# **SMITH DOUGLAS - RALEIGH**

TRUSS: A2

**REPAIR ID:** MII-REP01A1 (ATTACHED)

## STANDARD REPAIR DETAIL FOR BROKEN CHORDS, WEBS AND DAMAGED OR MISSING CHORD SPLICE PLATES

# MII-REP01A1

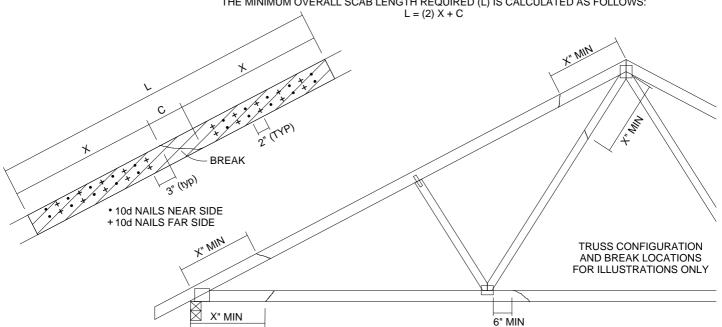
ATTACH 2x\_ SCAB OF THE SAME SIZE AND GRADE AS THE BROKEN MEMBER TO EACH FACE OF THE TRUSS (CENTER ON BREAK OR SPLICE) WITH 10d (0.131" X 3") NAILS (TWO ROWS FOR 2x4, THREE ROWS FOR 2x6) SPACED 4" O.C. AS SHOWN. STAGGER NAIL SPACING FROM FRONT FACE AND BACK FACE FOR A NET 0-2-0 O.C. SPACING IN THE MAIN MEMBER. USE A MIN. 0-3-0 MEMBER END DISTANCE.

THE LENGTH OF THE BREAK (C) SHALL NOT EXCEED 12". (C=PLATE LENGTH FOR SPLICE REPAIRS) THE MINIMUM OVERALL SCAB LENGTH REQUIRED (L) IS CALCULATED AS FOLLOWS:

THE LOCATION OF THE BREAK MUST BE GREATER THAN OR EQUAL TO THE REQUIRED X DIMENSION FROM ANY PERIMETER BREAK OR HEEL JOINT AND A MINIMUM OF 6" FROM ANY INTERIOR JOINT (SEE, SKETCH ABOVE)
